## BX PRV Station & Watermain Upgrade Reference No. 2016-E372.12.2

May 10, 2017

### ADDENDUM NO. 1

The following list contains questions received to this RFP process and their corresponding answers.

DRAWING NUMBER  
**M-02**

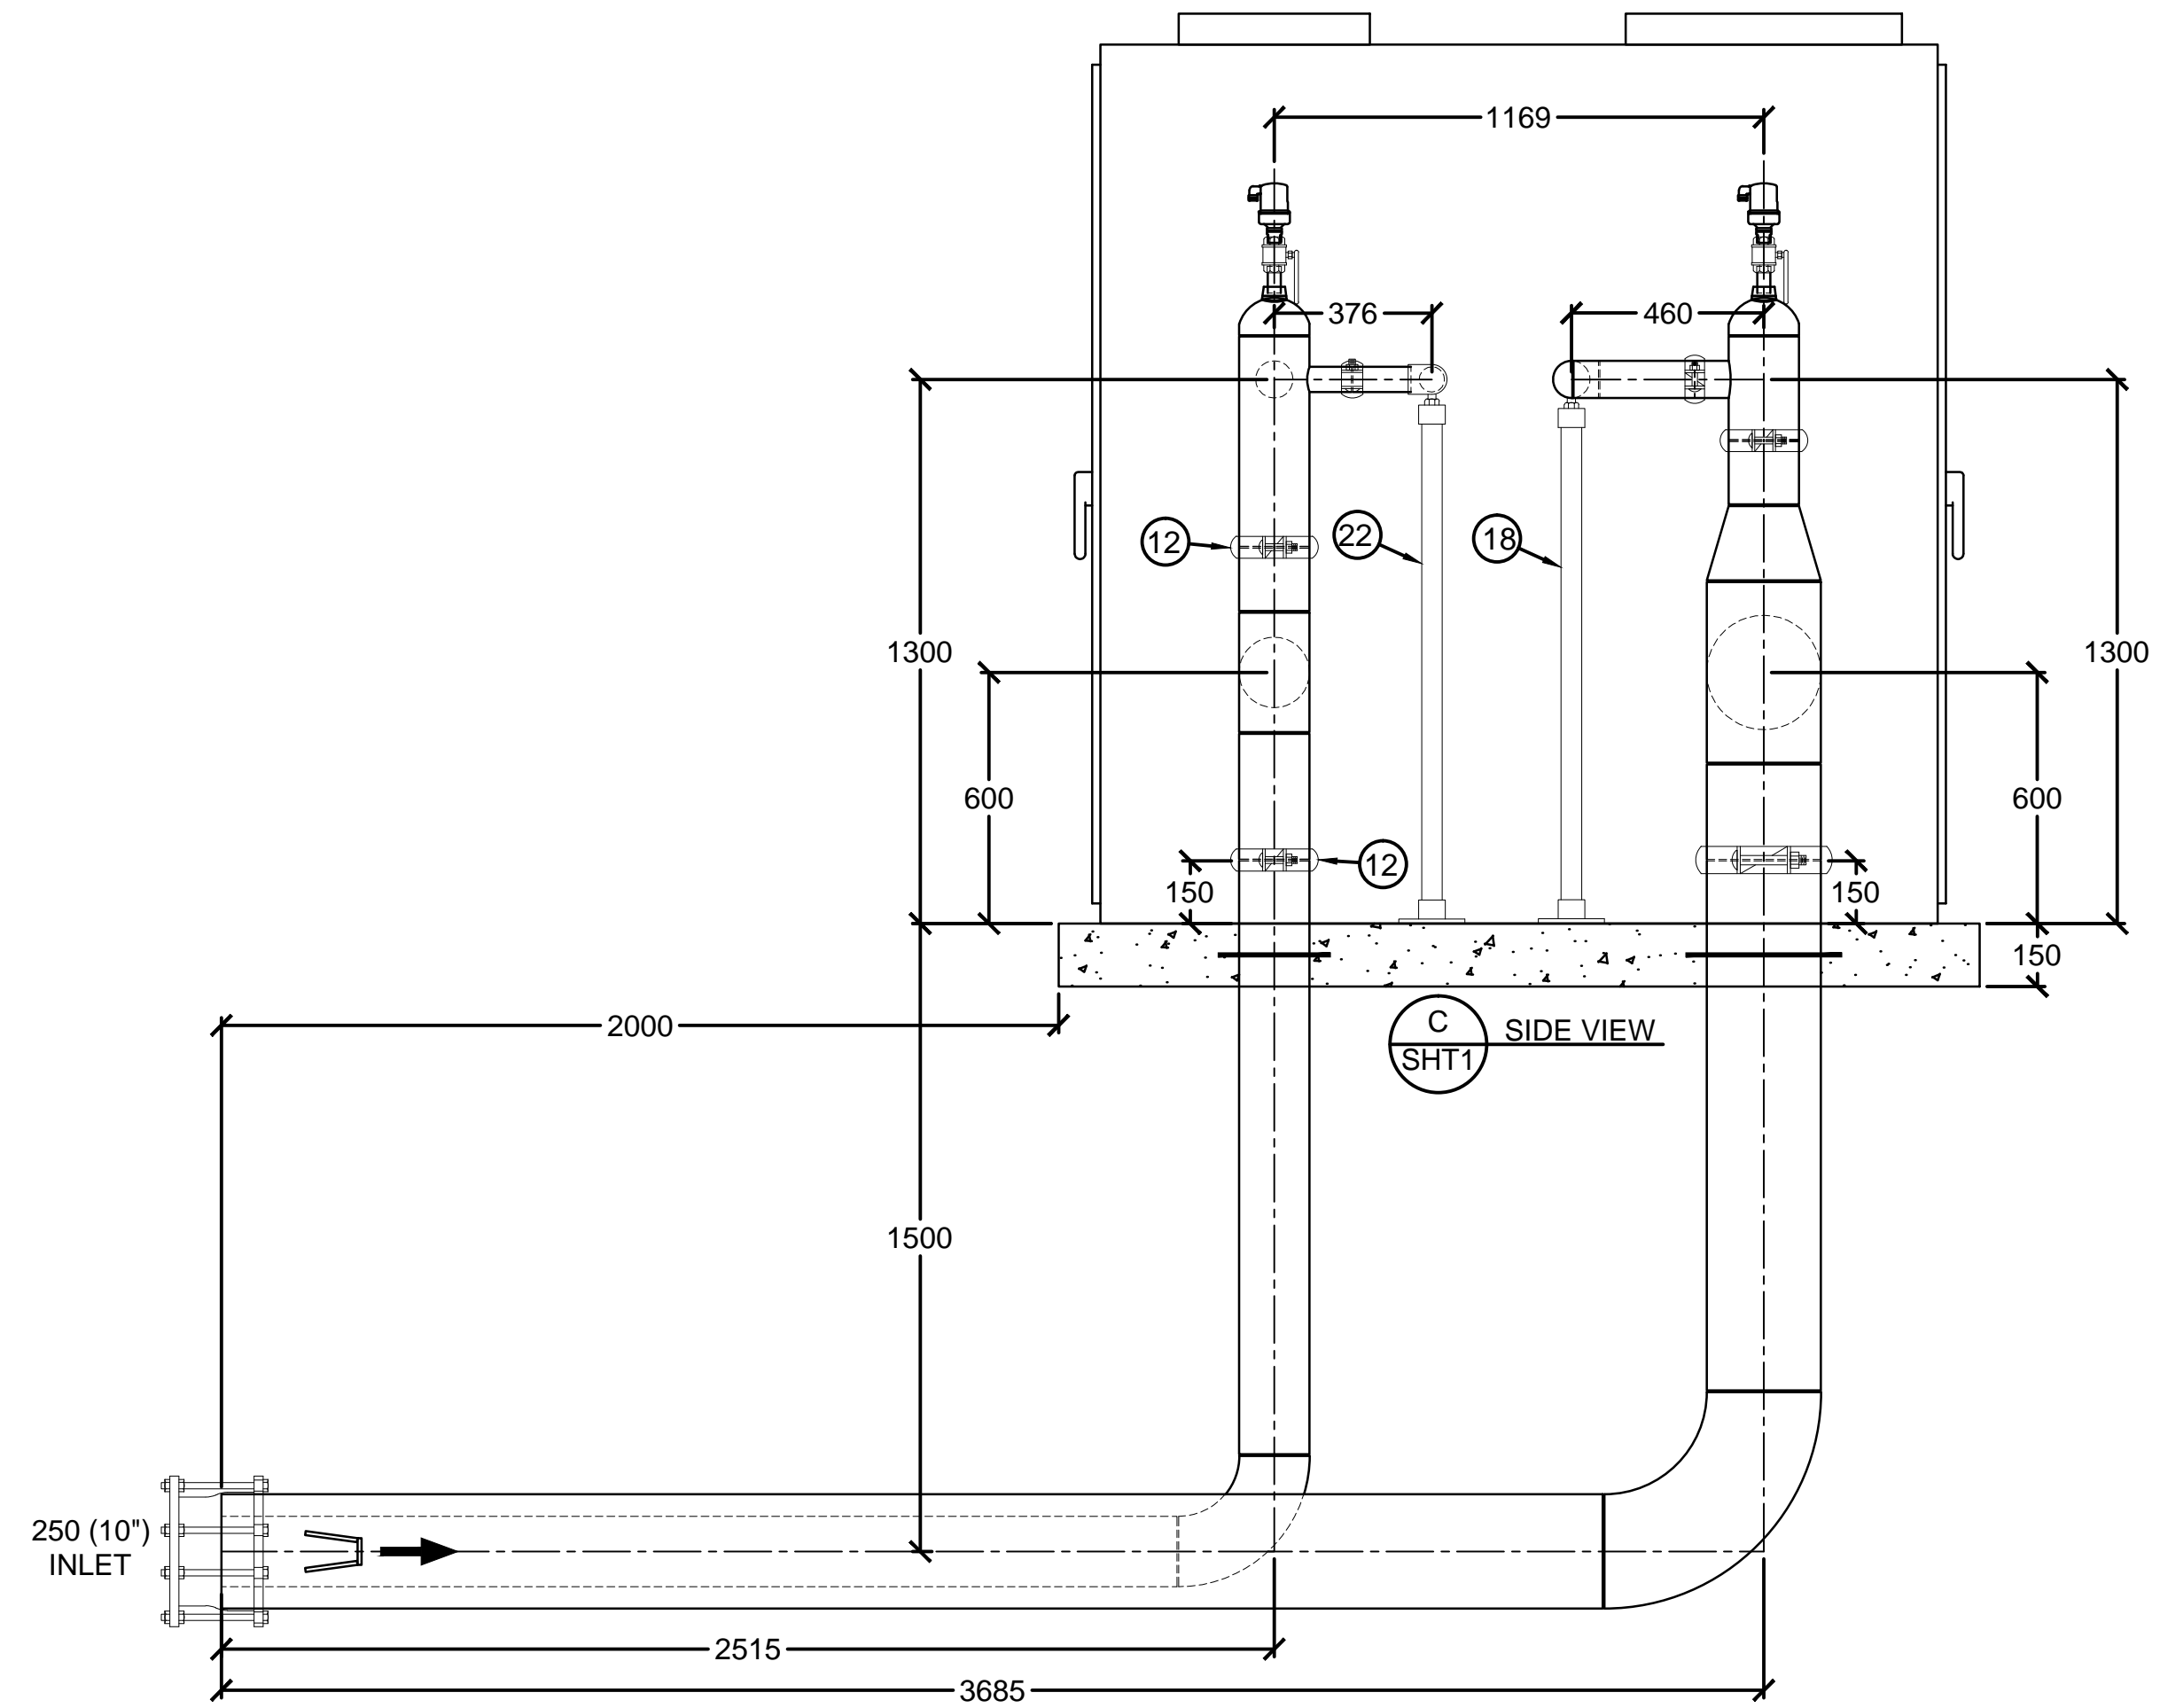
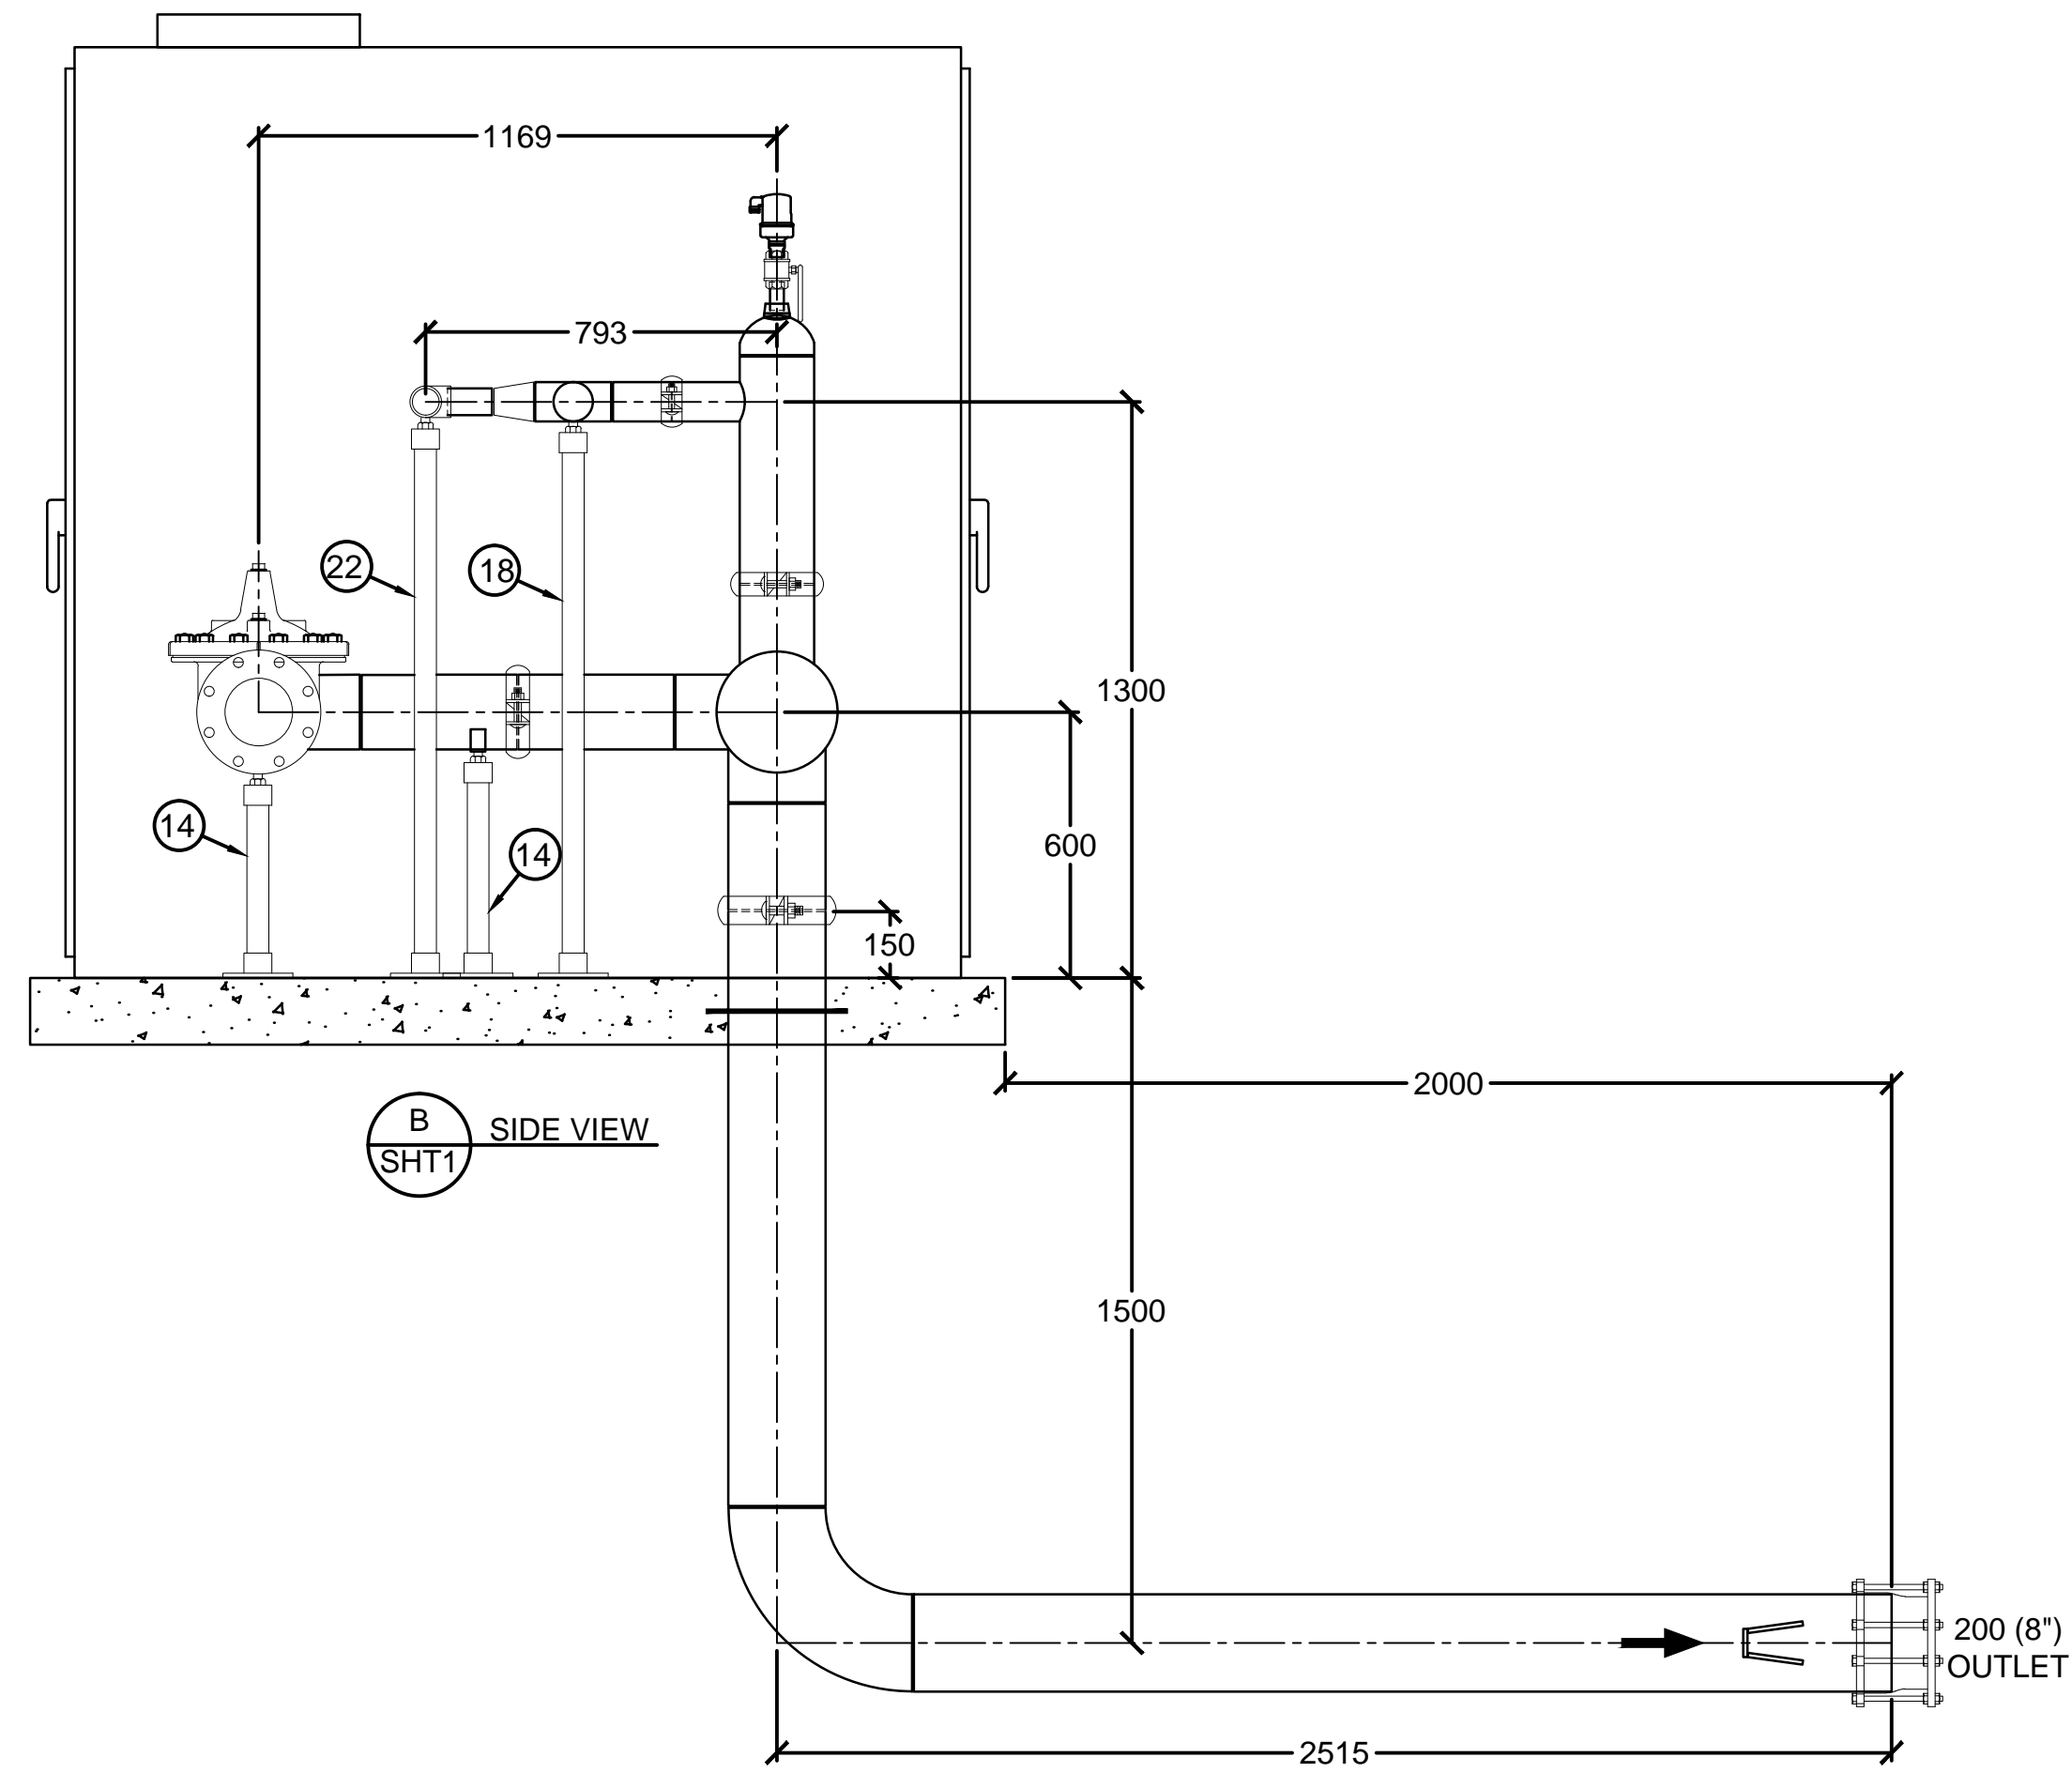
Q1	Is there currently a scheduled site meeting for this opportunity?
A1	<i>There will be a non-mandatory site meeting on <b>Tuesday, May 16<sup>th</sup> at 9AM</b>. The meeting will commence at the PRV site.</i>
Q2	M-01 shows inside dimensions of PRV chamber 4100L X 2000W X 2100H while M-02/03 identify inside dimensions of 4500L X 2000W X 2100H. Which dimensions are correct?
A2	<i>The correct dimensions are 4100L X 2000W X 2100H. Revised drawings are attached.</i>
Q3	Are granular base and granular sub-base, in relation to asphalt restoration, to be paid under SOQ or are they incidental to asphalt restoration?
A3	<i>Asphalt restoration will include restoration of the asphalt above the trench (base/subbase is included in the trench unit rate) as well as a grind and overlay 35 mm of asphalt as per MMCD G5 throughout the rest of the area shown for paving.</i>
Q4	What is the road structure for Silver Star RD and Dedecker RD?
